**OHIO TURNPIKE AND
INFRASTRUCTURE COMMISSION**

ADDENDUM NO. 2

PROJECT NO. 39-18-02

**PART A - MAINLINE PAVEMENT RECONSTRUCTION, MILEPOST 169.74 TO MILEPOST
176.34, SUMMIT AND CUYAHOGA COUNTIES, OHIO**

MINIMUM COURSE THICKNESS REQUIRED

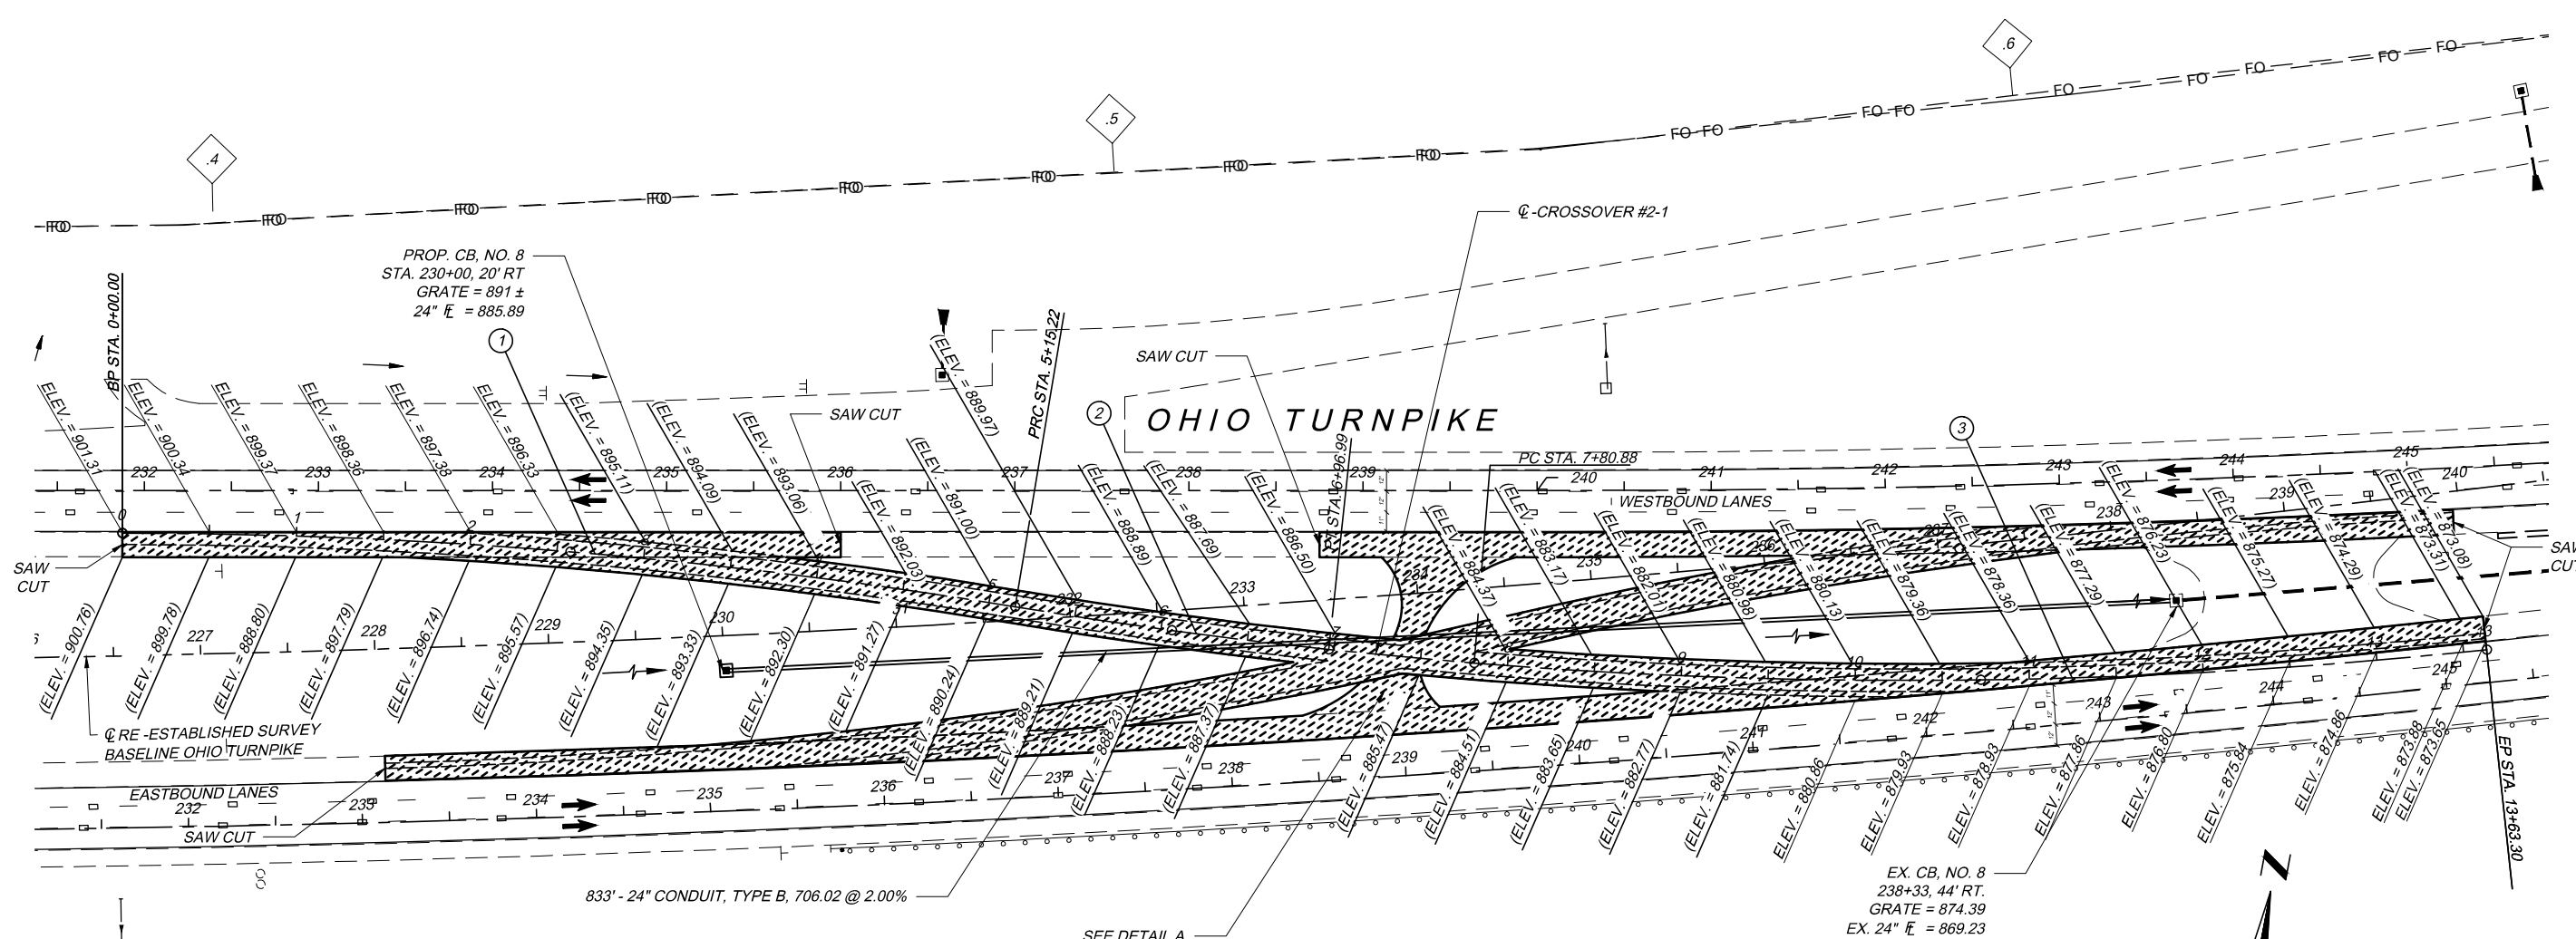
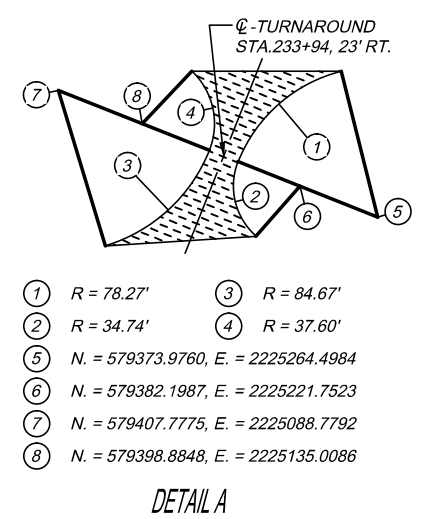
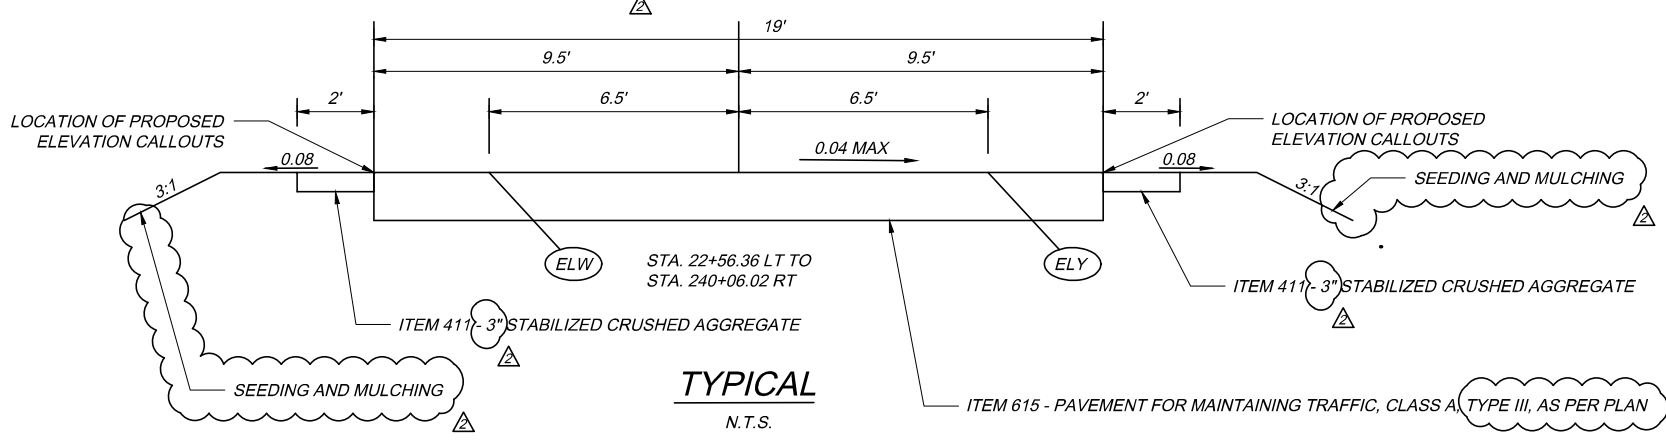
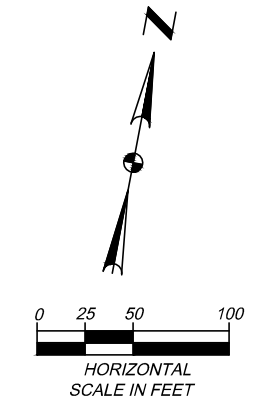
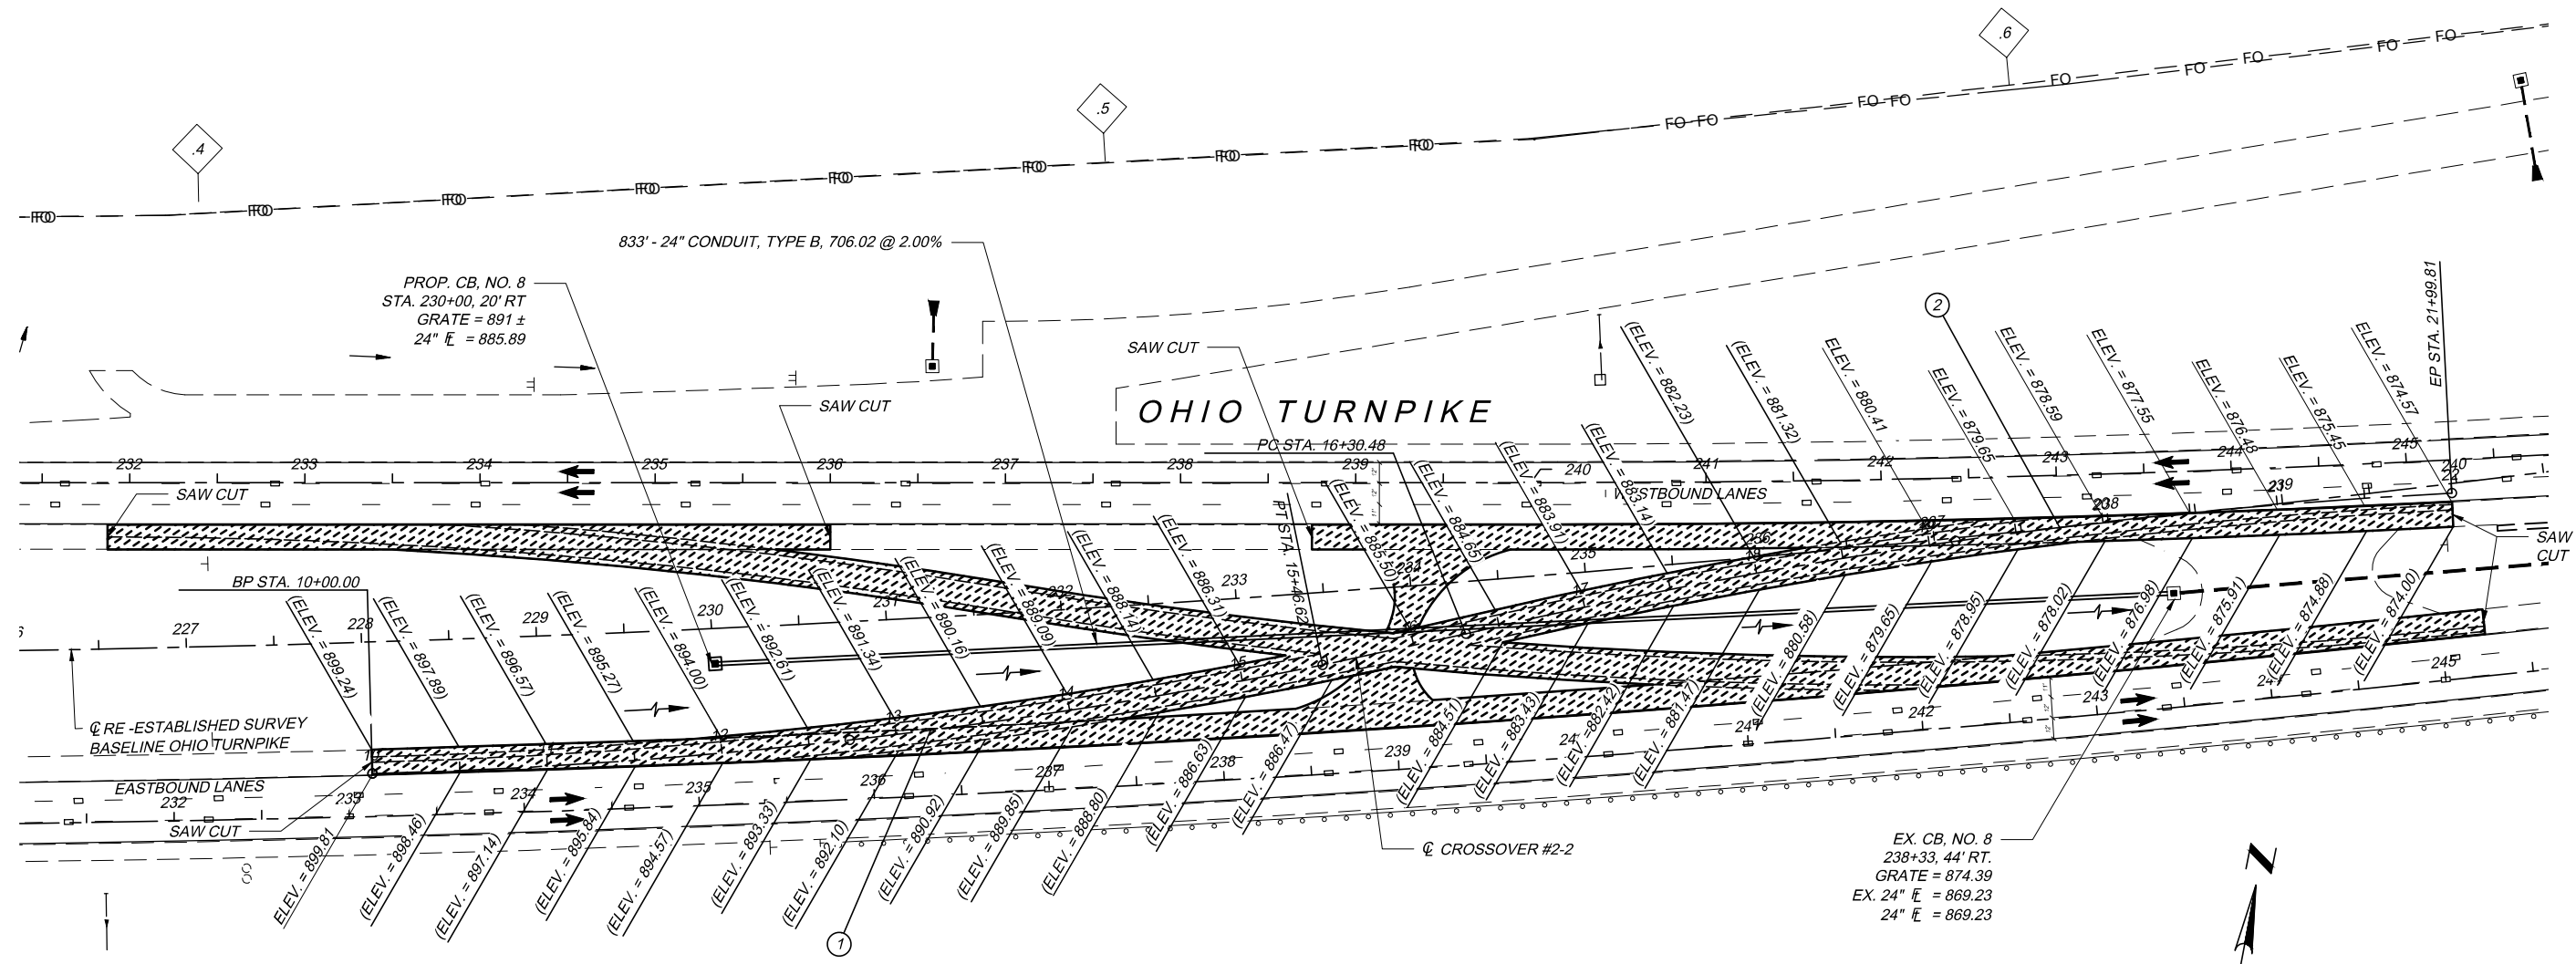
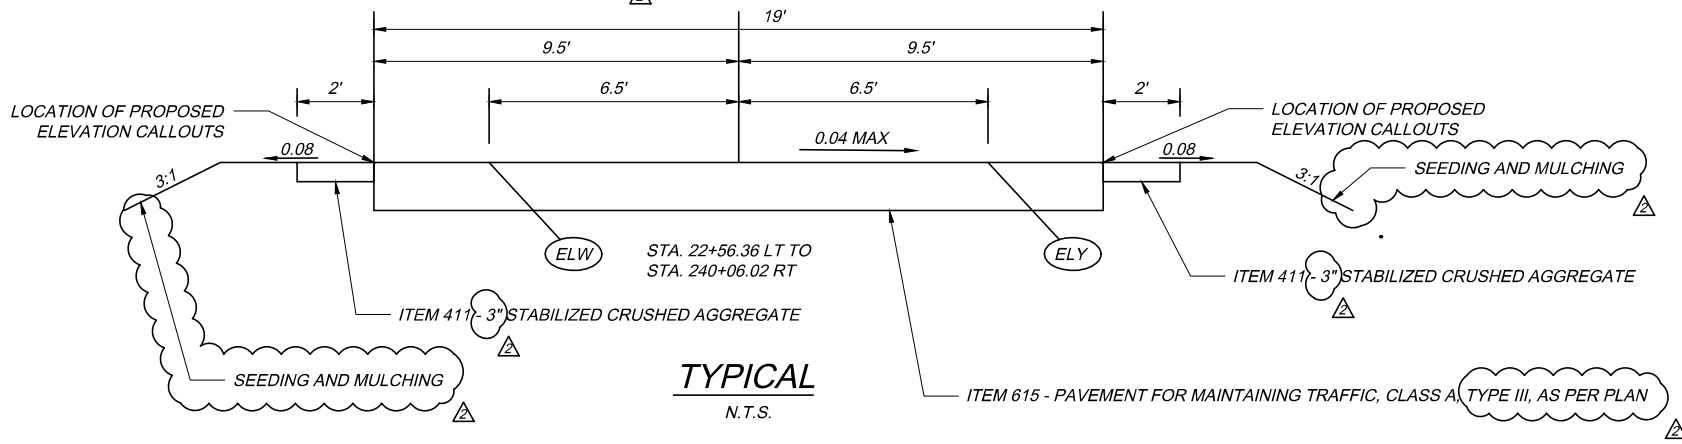
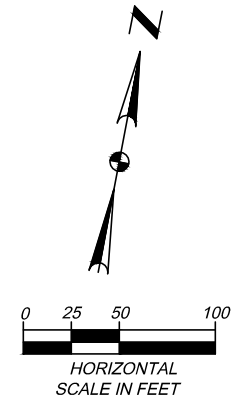
- Q#31 Plan sheet 192: Please verify if the 411 berm stone is to be incidental to the corresponding temporary pavement item (bid item 222) as well as please provide a thickness for installation.**

In addition, this Addendum No. 2 revises Plan Sheets 192 and 193 of 727 to add the minimum course thickness for the pavement buildup of Item 615 – Pavement for Maintaining Traffic, Class A, Type III, As Per Plan.
